4. US 101 Tumwater, Lees, & Ennis – Constructability Review **Piper Pettit – Design Team Leader**

5. US 395 NSC Spokane River Crossing – Constructability Review Amy Leland and Doug Olsen, Bridge Office

a) SR-16 Purdy Creek – Monique Anderson

b) SR-116 Chimacum Creek

Discussion Topic #1 – Ground Anchor Construction

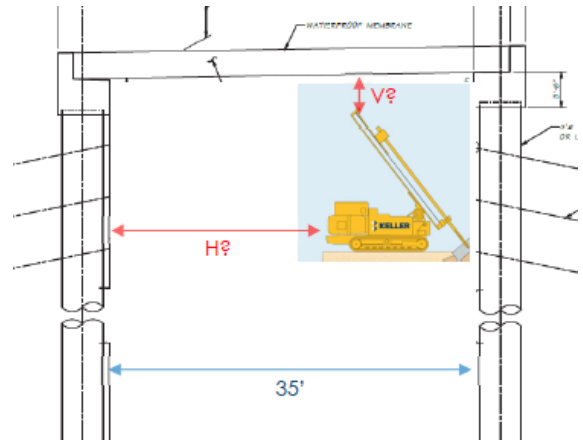
Q: Assuming the shafts are constructed and the lid structures are placed, the next step would be to partially excavate underneath the lids and begin ground anchor construction, possibly while traffic is using the structure. The smallest fish passage will be roughly 35 feet from wall face to wall face. How big of a drill rig can be used?

Q: Piper - Is there enough room for this to be constructible?

Q: Piper – Do you see anything that concerns you with this?

A/Q: Lance – Is there any way to stage this so that we could do some anchor work from the roadway, maybe through openings? Production for 100 ft anchors would be two for a shift.

A: Doug Watt – All of the contractors are going to put the largest drill they can in the opening as larger drills equate to more production.

A: Doug most drill rigs have a 32 to 34 ft long mast, but shorter are available. Ryan with DBM concurred, but stated he was more concerned about headroom and anchor angle. It was suggested that having two to three feet of clearance to the mast be the minimum clear space both to a vertical wall or horizontal overhead obstruction. Masts as short as 8 feet can be used, but they greatly reduce production rates. To crawl a rig into the opening, at least 8 feet of space is required, but they may not be able to mast-up with only that amount of room. (Note taker insertion – from other constructability reviews anchor rigs typically need the anchor about 2 feet above the working grade elevation and no more than 8 feet above).

A: Piper – Possibly but lane closures are a big deal for the community, and we are trying to limit the duration of lane closures.

Discussion Topic #4 Old Concrete Roadway

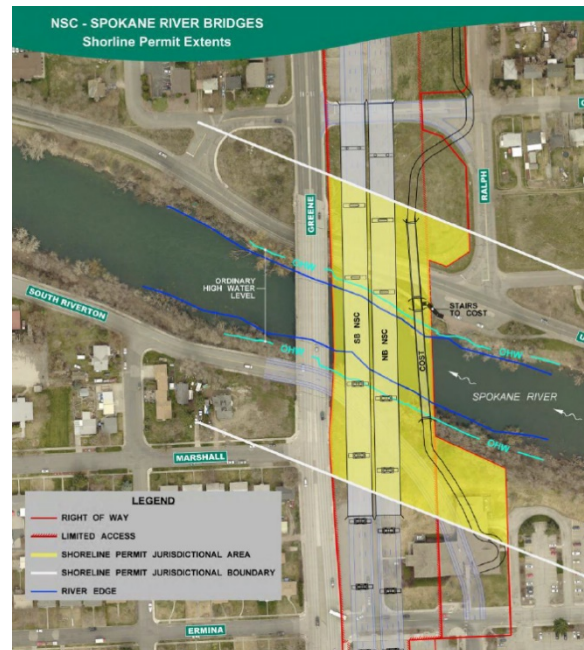
Q: Piper – Can you drill through the concrete?

A: Unknown – It shouldn't be a problem.

Pier 5 location of SB bridge

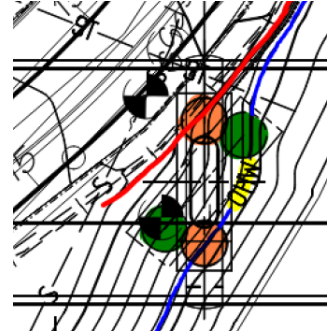
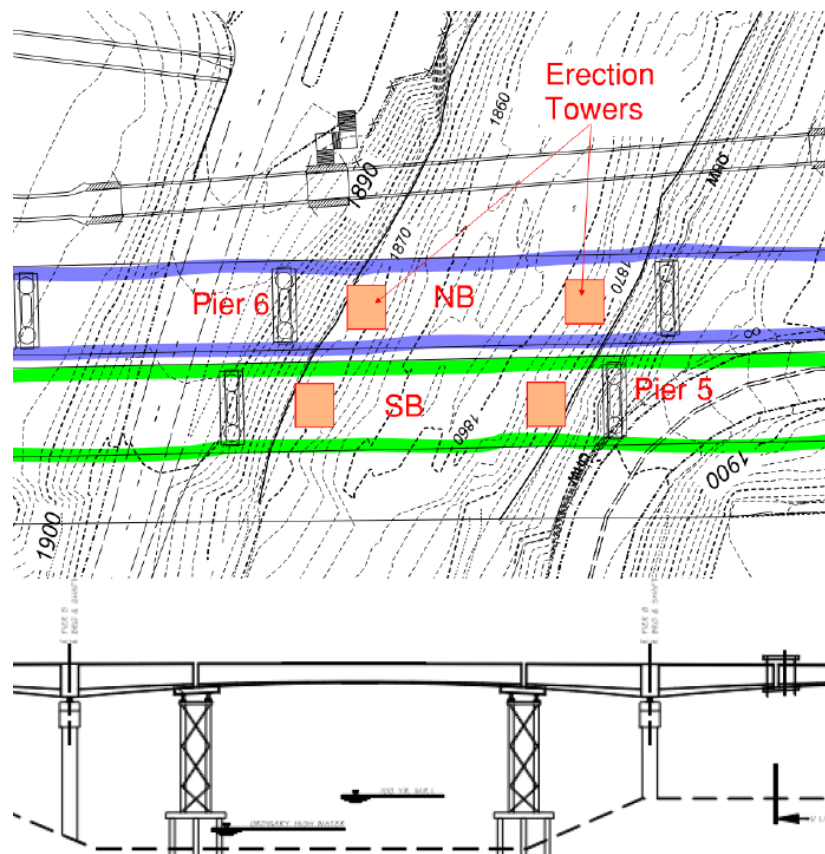
Q: Amy – How close to the wall face can you construct 10 ft diameter shafts?

Q: Tait – Will temporary casing be required for these shafts?

A: Amy - Likely.

A: Tait – The distance from center of shaft to front edge of the oscillator is just under 10 feet, but the oscillator needs wiggle room so 11 feet from center of shaft is needed.

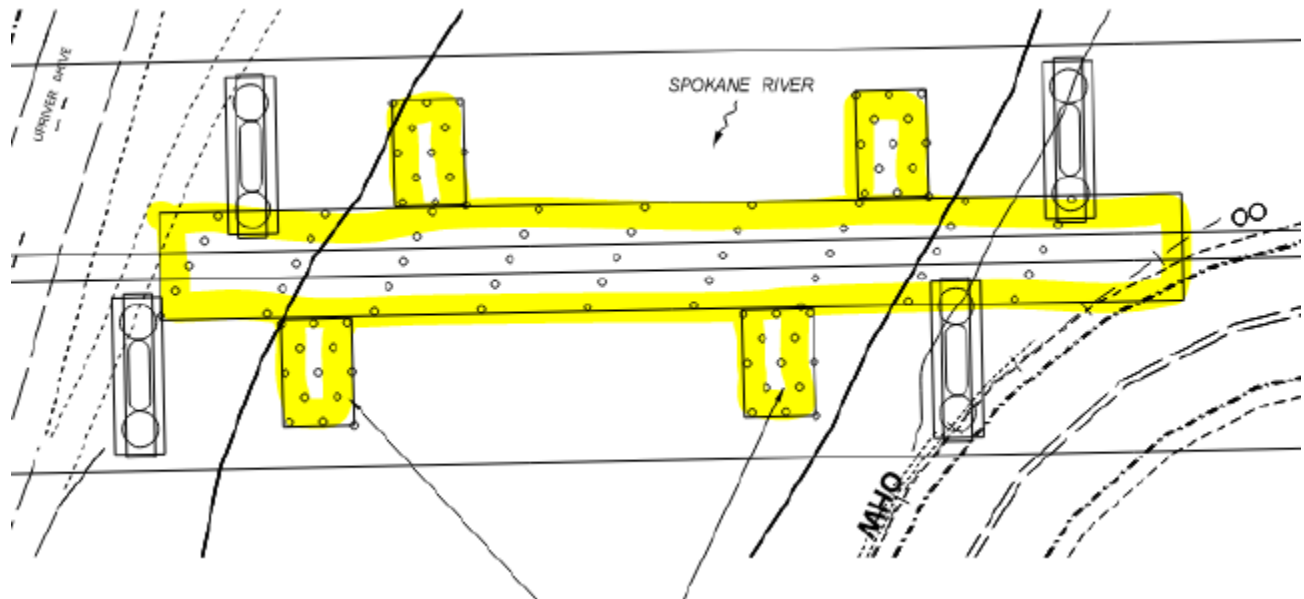
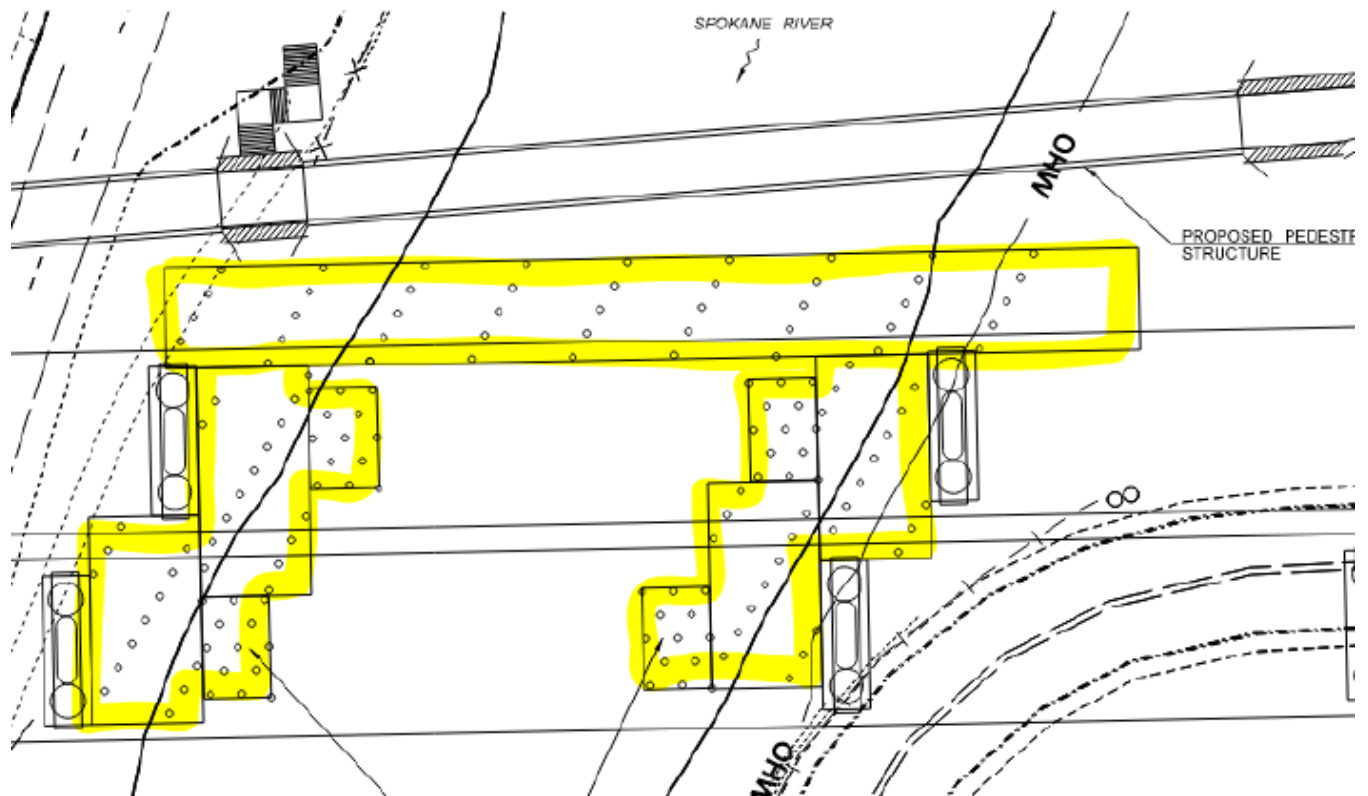
Q: Amy - Trestle Questions

- Are both trestle options feasible?
- Is one preferred over the other?
- Should an extension of the in-water work window be requested?
- Do you foresee issues with trestle pile removal when the girders are in place? Piles must be removed.

A: Lance – Those are questions better suited to the AGC group.

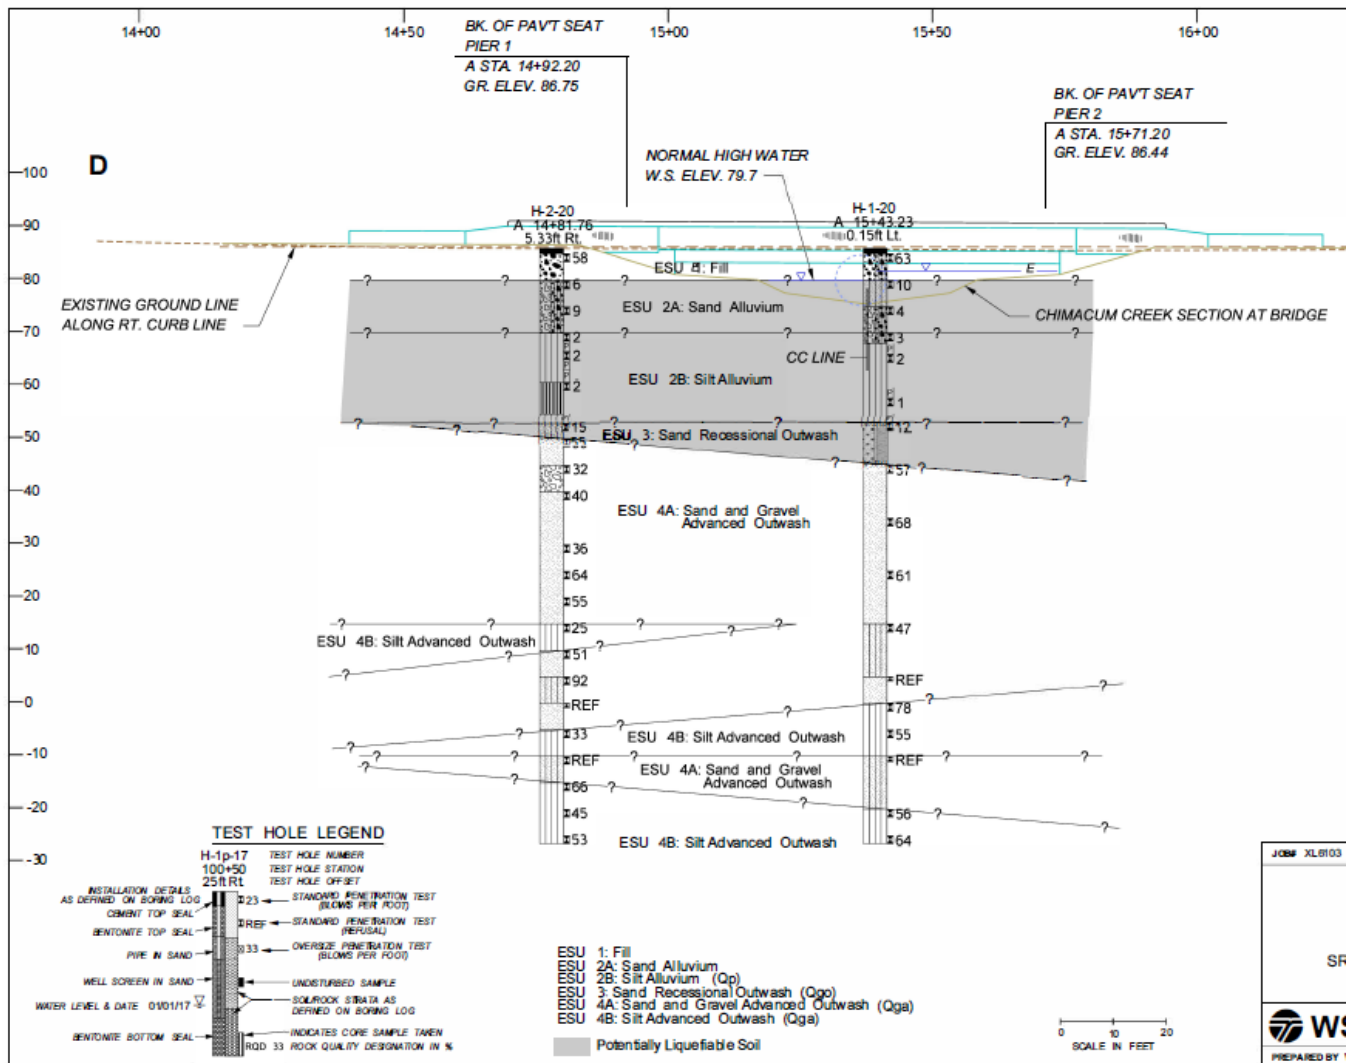
object to the recommendation from geotech that only the oscillator/rotator be used to install temporary casing for this job?

Lance Rasband indicated that Michels would pursue using casing to support the soils rather than slurry and that based on the dense soils conditions the preferred method of casing installation would be by oscillator/rotator. Jim Cuthbertson asked the group if they thought telescoping of casing would be necessary to install casing using a vibe hammer with drive and drill methods. The team felt that to install casing conventionally, telescoping would be required. The use of a dig crane with a grab along with oscillator or rotator would also afford the contractor the ability to use additional slurry head to counteract any artesian pressures should they be encountered. Overall, the team was agreeable to requiring the oscillator or rotator for this project. John Tuttle did point out that based on the logs, he thought slurry would be effective to stabilize the excavation.

For the three shafts that require permanent casing, it was asked if the oscillator casing would be left behind or if a slip casing would be used. Jim Cuthbertson explained that the contractors would not use the oscillator casing. They would use the permanent casing as the “dig” casing by welding teeth to its tip and advancing that. The bridge office plans to use casing with 1-inch wall thickness.

The contractors thought that drilling from the existing roadway would provide the best access. This will mean the top of shaft will be 30 to 40 feet below the ground surface. Jim Cuthbertson asked if casing shoring would be needed. The contractors thought that after shaft construction they would backfill the excavation with pea gravel and not need casing shoring.

Conclusion: The full depth permanent casing at pier 2 will necessitate that the oscillator or rotator be used to install the casing because of the very dense soil conditions. It is believed that conventional shaft construction methods to install the casings would be very difficult, and although slurry would be effective at maintain stability in the outwash materials utilizing the oscillator or rotator for the entire job is prudent.

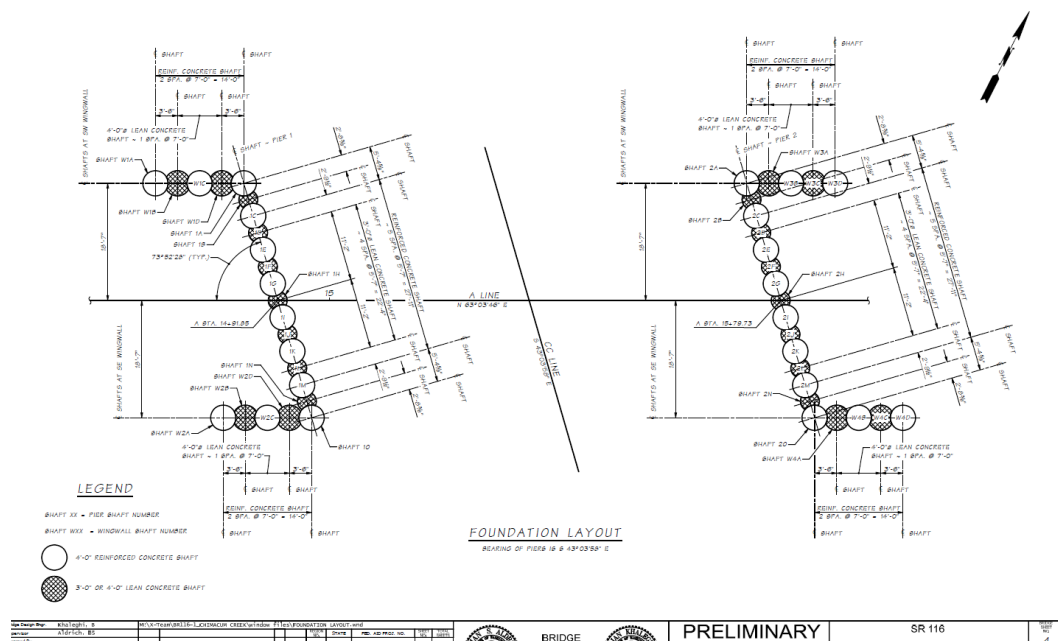
For the secant pile option, structural shafts are thought to be 4 feet in diameter with lean shafts at about 3 ft diameter and would extend about 7 feet below the thalweg for scour. The leans would likely be above the artesian source, but the structural shafts would still likely encounter the artesian source.

The ADSC team though the casing length and head necessary to maintain stability is not feasible. They felt that depressurization wells would be necessary, but depressurization could also lead to settlement. Geotech acknowledged that this would take more investigation and design.

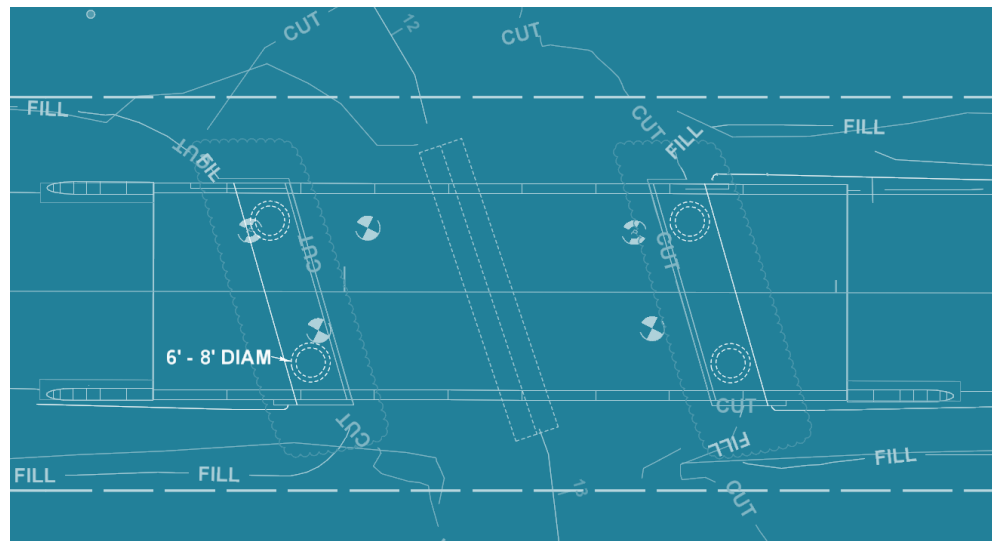
The project office is also considering fewer larger diameter shafts, maybe two per abutment, with a more conventional abutment design. The abutment may or may not need a cofferdam for construction and containment since it is within a wetland.

Of the options presented, the ADSC felt that the best option would be four shafts. The risks of doing 4 larger shafts is less than doing 46 smaller diameter shafts, based purely on the number being installed. A reasonable estimate for the shaft construction of the shafts would be one week per shaft. To contain the slurry during construction you would probably need three baker tanks on-site. Depressurization of the artesian is needed. With dewatering there would not need to be a restriction on the method of shaft construction, conventional construction would be possible.

3. Project Review - US 101 Ennis, Lees, & Tumwater

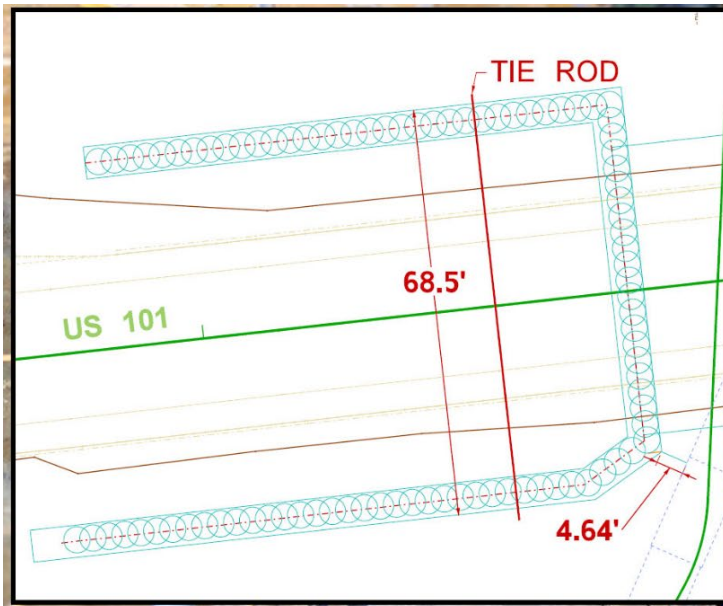
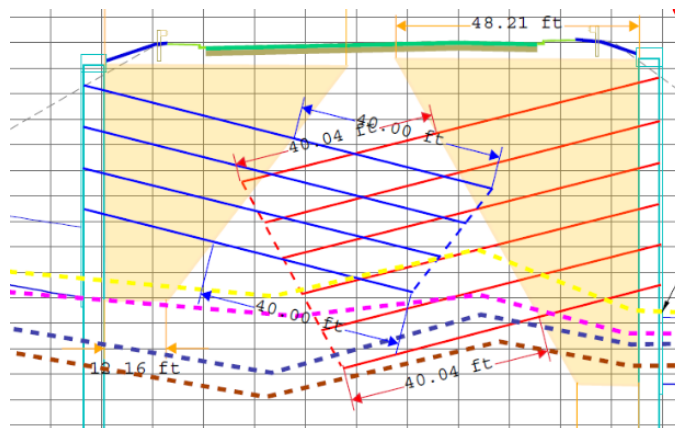
The team has revised the wall alignments. The latest concept has the walls tucked tighter to the roadway shoulder and they are considering using tie rods between the walls. The walls are tall enough that they can't cantilever and the thought is that typical ground anchors in one wall will conflict with the anchors on the opposite wall. Drilling between the walls and using walers on both walls would eliminate the potential conflict. The figure below shows the concept being discussed.

- ▶ How feasible is it to drill tie rods between perpendicular secant pile wingwalls?
 - Target on opposite wall = 3' wide gap through lean shaft (6' diam structural & lean shafts, 9' o.c.)
- ▶ Tumwater = 68.5' face to face of wall
- ▶ Ennis/Lees = 120' face to face of wall
- ▶ How significantly would the presence of 6"-8" cobbles affect drilling accuracy?
- ▶ Any mitigation strategies? Bump casing size? Can you course correct if the drill bit deflects?

The distance from face to face is 68.5 ft at Tumwater and 120 ft at Ennis. The top row would be 5 – 8 ft below the grade, and there would be multiple rows vertically. The consensus of the team was that conventional tieback drills would have a very difficult time trying to hit a 3 or 4 ft target (a non-structural shaft) with enough accuracy and elevation control. The casing segment joints and the casing itself would allow too much deflection for the accuracy expectation to be achieved.

There was discussion about doing this like more conventional inclined ground anchors bonded within the soil mass itself but there is a very significant risk of anchor interference and damage. With Tumwater having only 68 ft between walls, there were also concerns about having enough room for both a bond zone and no-load zone. As shown below:

Topic 3 Drilling through CL. 3000+ concrete shafts

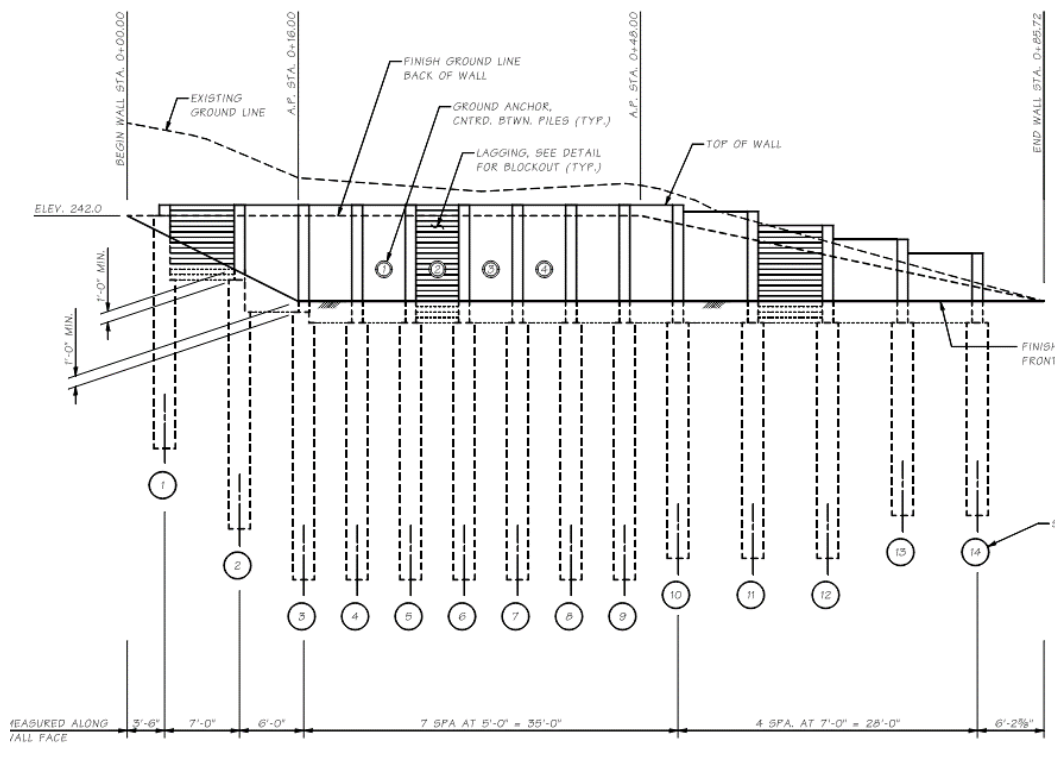
For the secant pile concept, scour is a concern especially for the secant piles that are acting as an abutment parallel to the stream. There are concerns that the non-structural shafts could be prone to scour below the high water elevation. To eliminate that potential, the team is thinking about having the non-structural shafts be more conventional concrete (class 3000) from the toe to above scour elevation (the bottom 15 feet) and then be lean mix to the top of shaft. The team thought it would be better to pour the entire shaft as structural concrete and not try to change materials. Getting the material change to occur at

the proper location would be difficult when placing concrete by tremie methods. The structural and lean will have a mixing zone and creating a defined material change is very difficult.
